**Intel® Pentium® 4 Processor in
478-pin Package and Intel®
845/845E/845G/845GL/845GV/
845GE/845PE Chipset**

Platform Design Guide Addendum

**For Support with Intel® Celeron® D
Processor in 478-pin Package**

Revision 1.1

Figure 1. Socket Sense Circuit

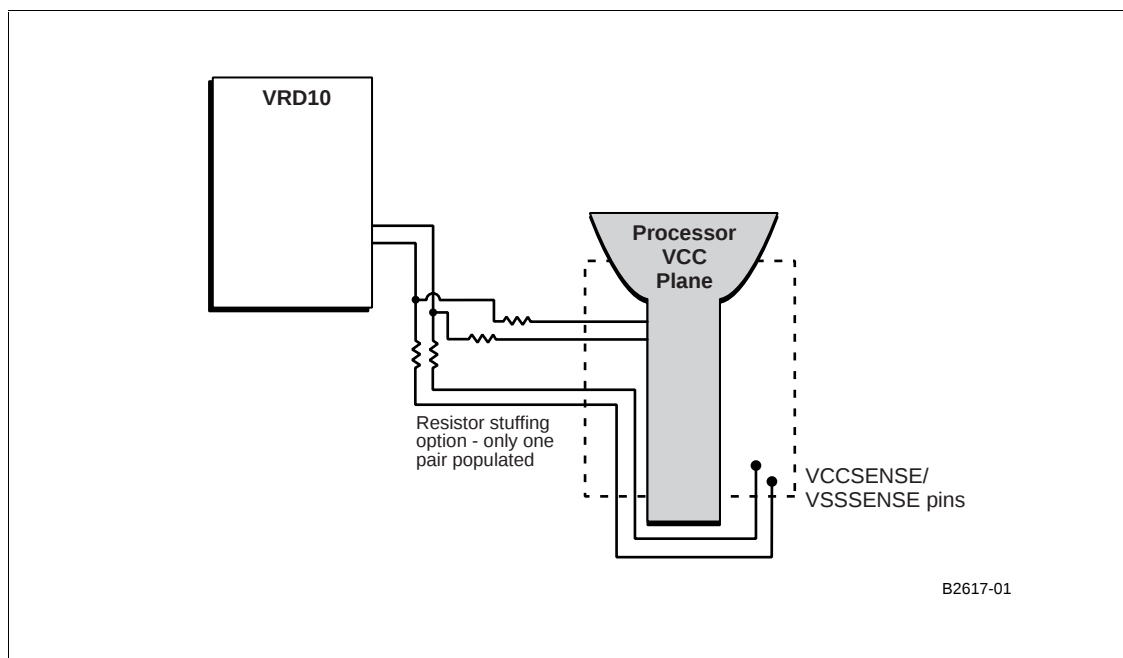
The compatible platform should have additional routing from the VRD 10.0 to the processor and resistor stuffing options should be used to select socket sense option.

Figure 2. Bi-Directional PROCHOT# Circuit

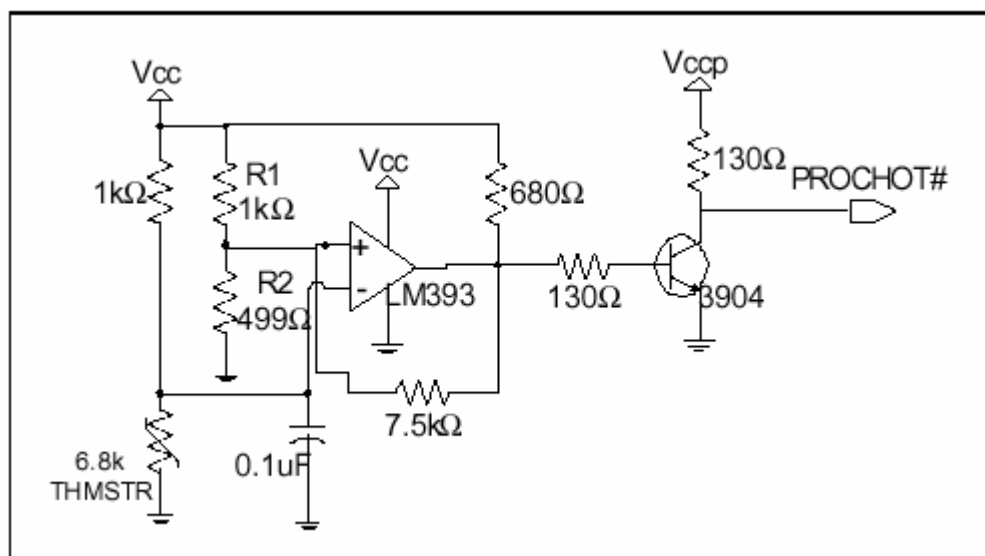
Intel recommends that the compatible system boards be designed to support the Intel Celeron D processor in the 478-pin package. These guidelines include an ICC_MAX and a VR_TDC (VR Thermal Design Current). The processor voltage regulator (VR) solution should be designed to support ICC_MAX electrically for brief time periods. The voltage regulator solution should also be designed to support a minimum of VR_TDC indefinitely within the envelope of system operating conditions. The VR_TDC limits of the system board are typically governed by the system board thermal limits. Intel recommends that system boards designed to the above guidelines implement a VR thermal monitor circuit.

For this circuit implementation, the thermistor (THMSTR) should be placed in the hottest area of the VR. As the thermistor heats up, its resistance goes down. This creates an error voltage based on the resistance of the thermistor and the voltage reference provided by R1 and R2. The values of R1 and R2 should be adjusted to calibrate the circuit for a specific system board design so that it asserts PROCHOT# when the VR reaches its thermal limit. The values of R1 and R2 in Figure 2 are included as an example. The value of R2 is adjusted to calibrate the circuit so that PROCHOT# is asserted when the VR reaches its thermal limit in the system that it is intended to operate in. An adequate VR cooling solution should be implemented such that VR_TDC current levels can be maintained indefinitely.

Figure 5. Reset Timing Circuit - 1

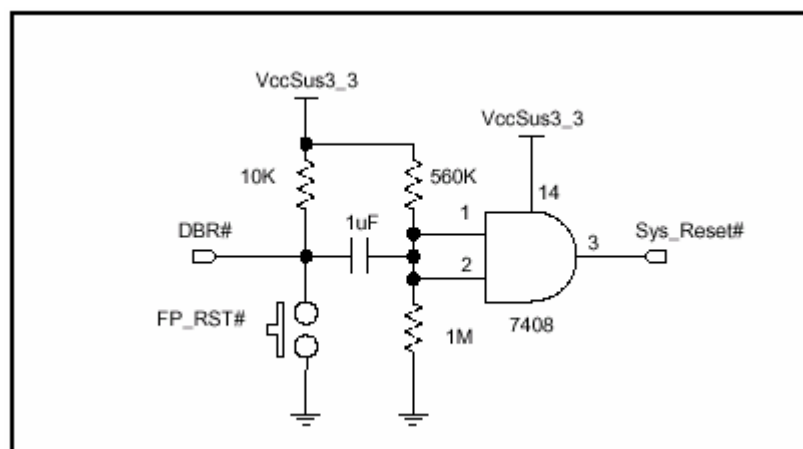
The front-panel reset switch (FP_RST #) is connected to SYS_RESET# to reset the whole system. The reset timing may violate the system stability conditions. To prevent this condition, the following two schematics are recommended to generate a 20 ms $\pm$ 20% pulse reset signal. Compatible platforms should implement either of the two timing circuits shown in Figure 5 or Figure 6.

Figure 7. Voltage Translation of INIT#

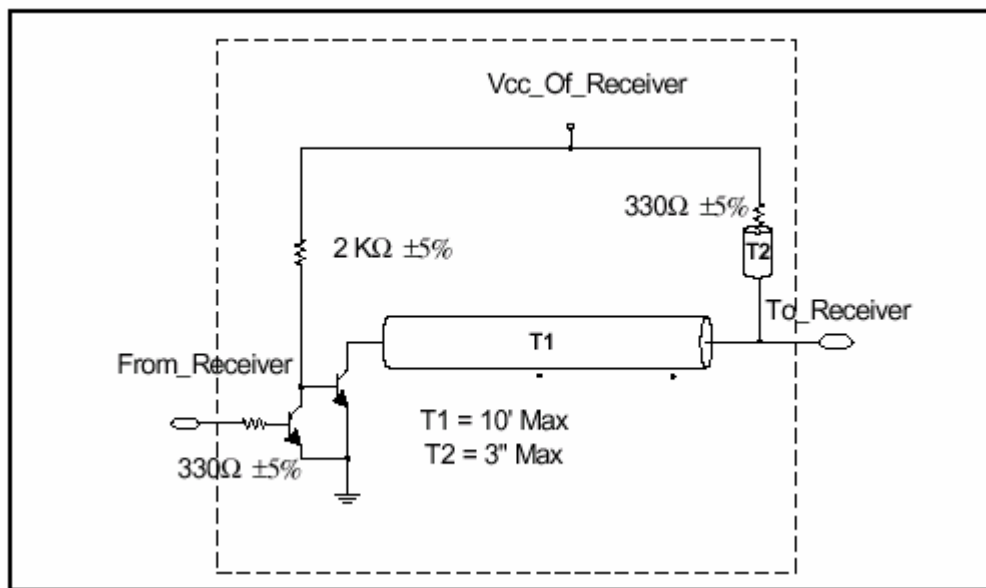
The recommended logic circuit for level shifting the INIT# signal has changed. The lower processor VID has led to changes in the circuit and input resistor values.

Figure 8. Voltage Sequence Block Diagram

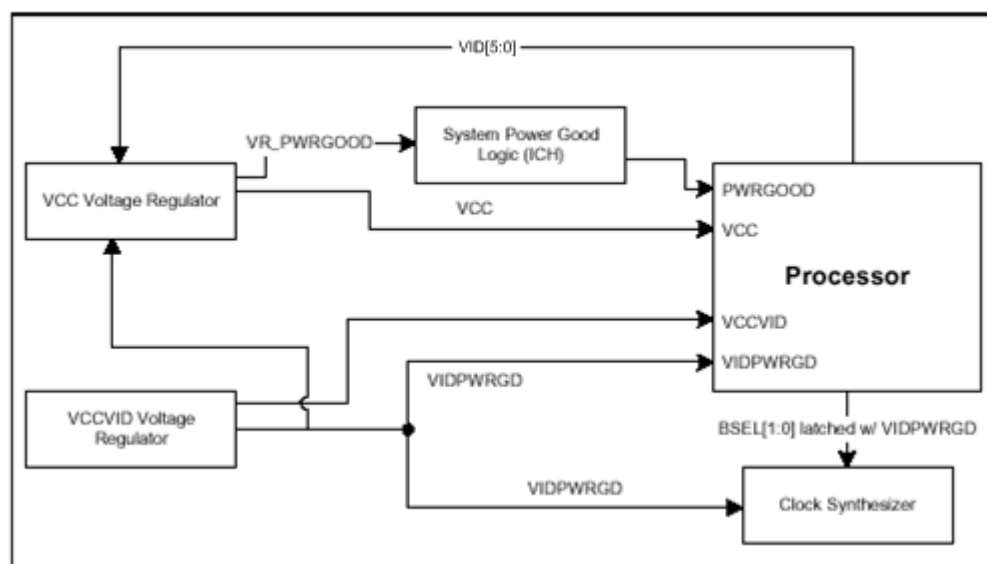
To support the Intel Celeron D processor in the 478-pin package, there are additional power sequencing requirements. This is mainly due to the addition of a VIDPWRGD input to the Intel Celeron D processor in the 478-pin package. This input is designed to indicate when the VCCVID voltage is stable and the processor is able to drive the VID[5:0] outputs. A block diagram of an example implementation is shown in Figure 8.
